**HOWARD COUNTY HEALTH DEPARTMENT**  
**BUREAU OF ENVIRONMENTAL HEALTH**  
**WELL & SEPTIC PROGRAM**  
 TEL: (410)313-1771 FAX: (410)313-2648

**Information Form for the Installation of the Well Pump, Pitless Adapter, and Supply Piping**

Name of Property Owner: Matthew Ganim Telephone #: 410-882-2152  
 Subdivision: \_\_\_\_\_ Lot #: \_\_\_\_\_ Well Tag #: HO-94-1172  
 Site Address: 7454 Lant Rd  
Fulton MD 20759

PICS FROM National Water Service (emailed on 4/30/24)

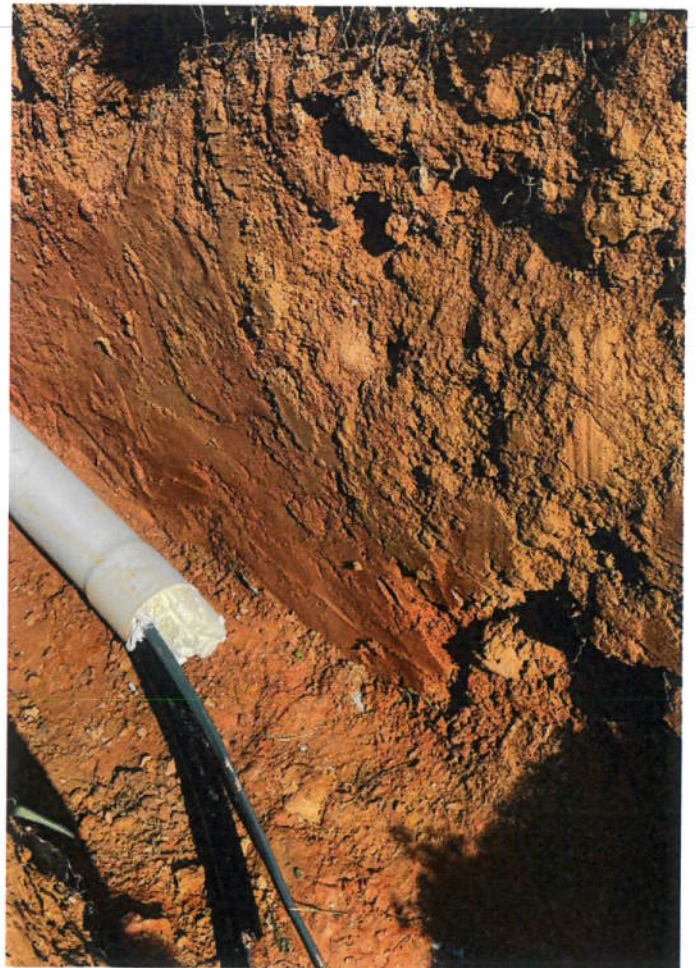
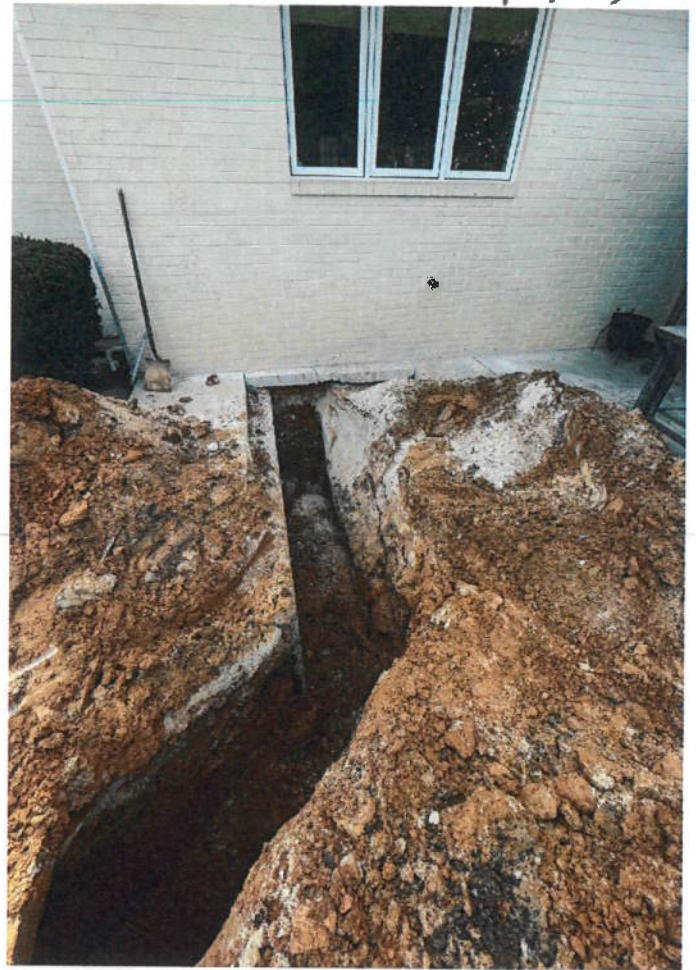
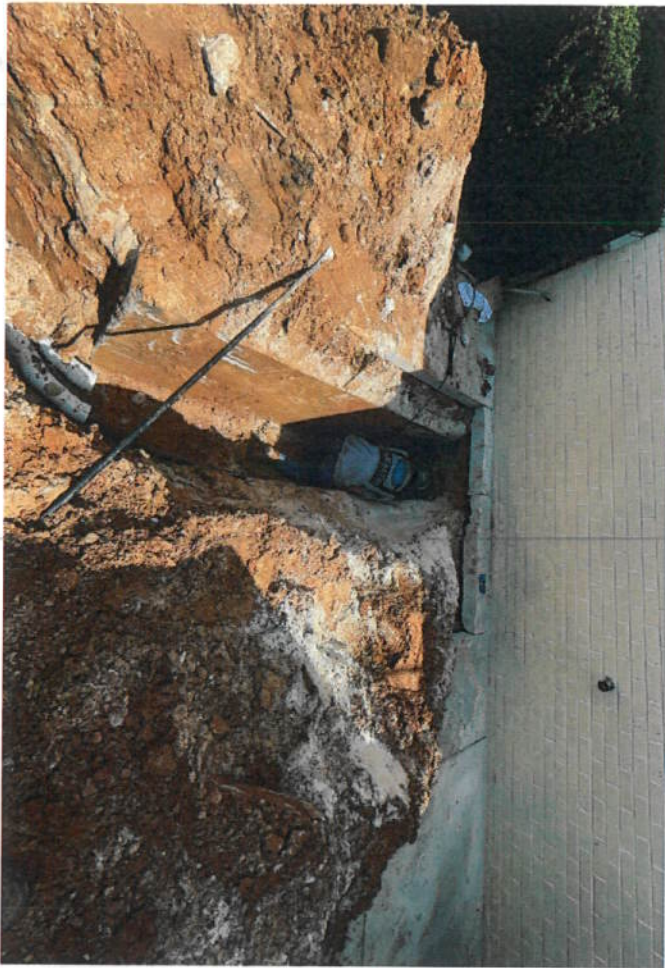
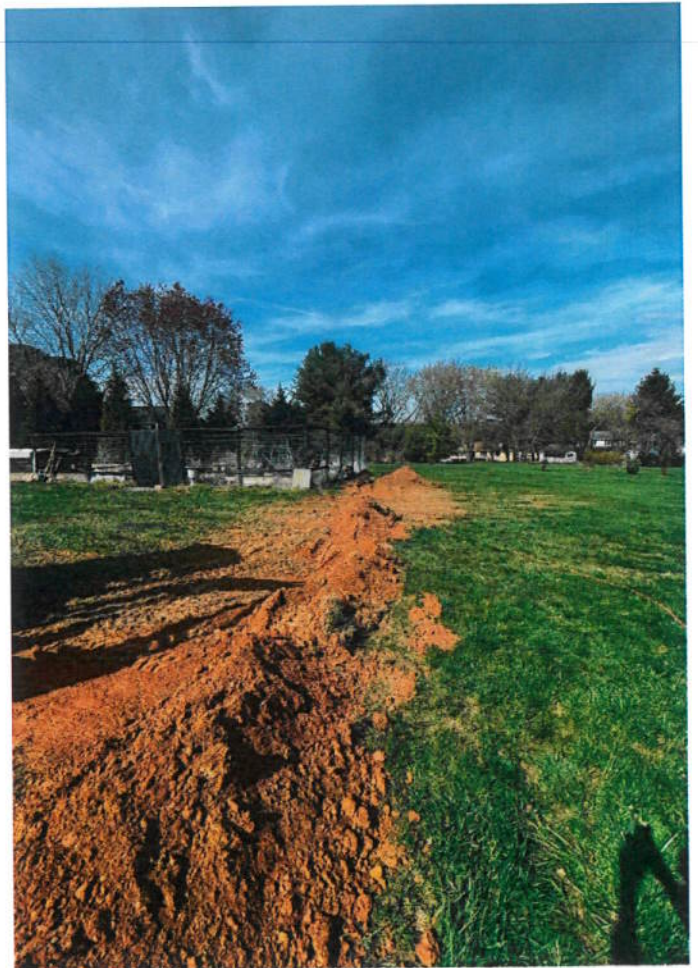
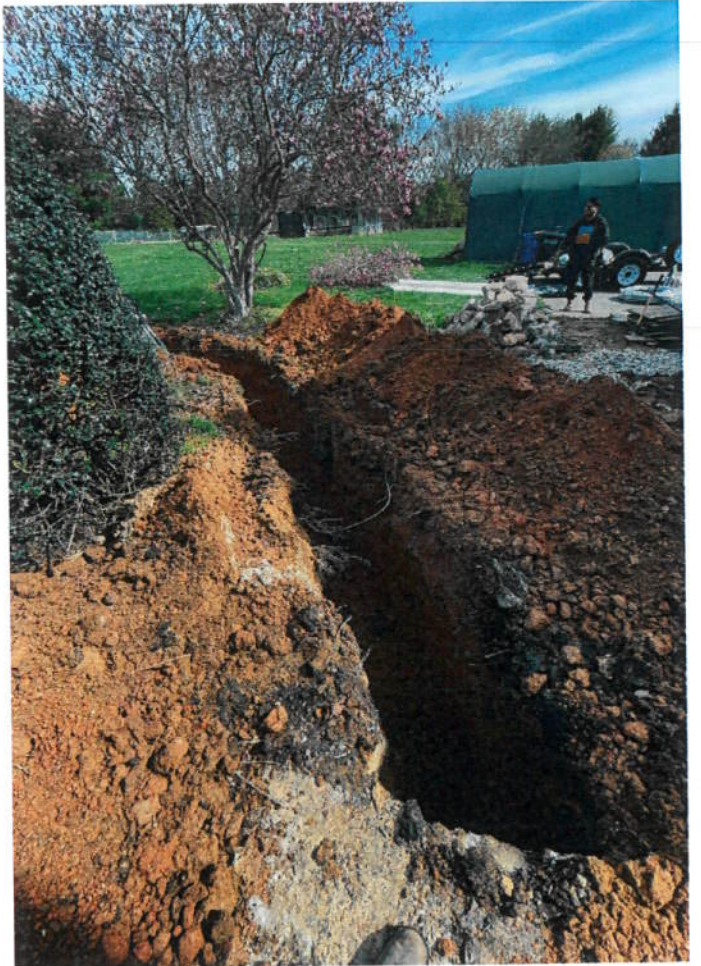
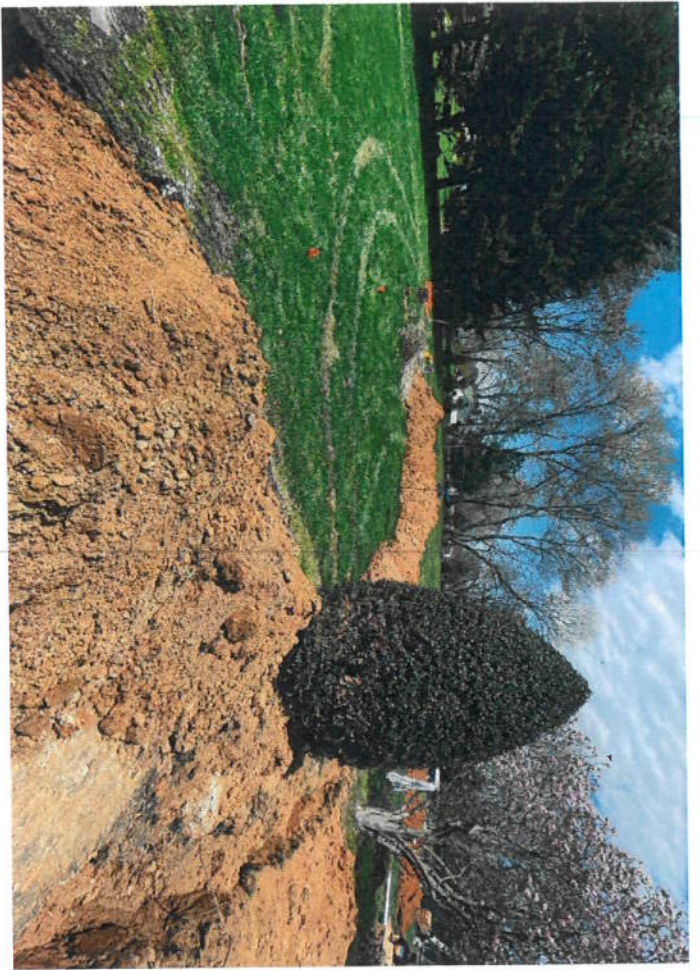
David, Also one quick follow up question. If you installed a new stainless steel pitless adapter because the original brass one was corroded, then why did you leave the corroded brass fitting and install the new one in a new location on the well casing? The old brass fitting was left in the casing and the old well line had a pvc cap on it. Could the new pitless adapter be installed in that hole in the casing that's already there, which was also 36" below the original grade?

LOCATION DIAGRAM

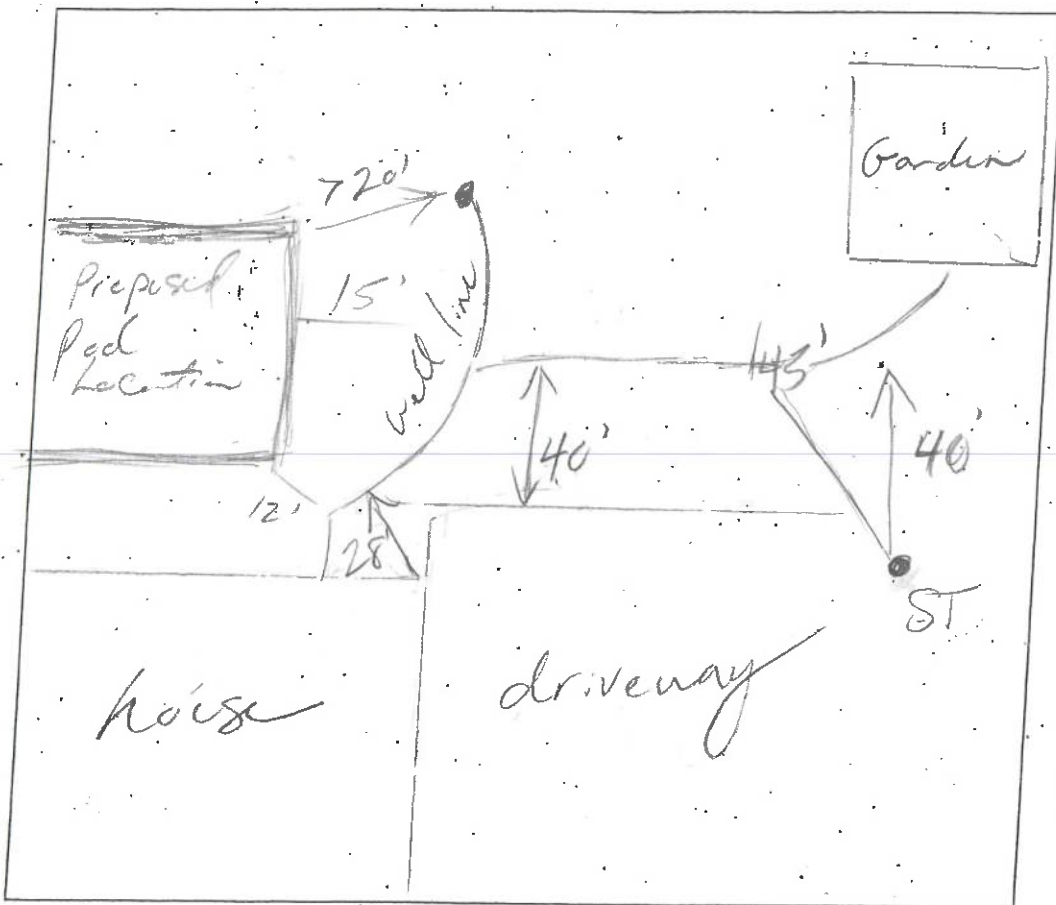
COMMENTS: well line to pod status 12-15'  
\_\_\_\_\_  
\_\_\_\_\_
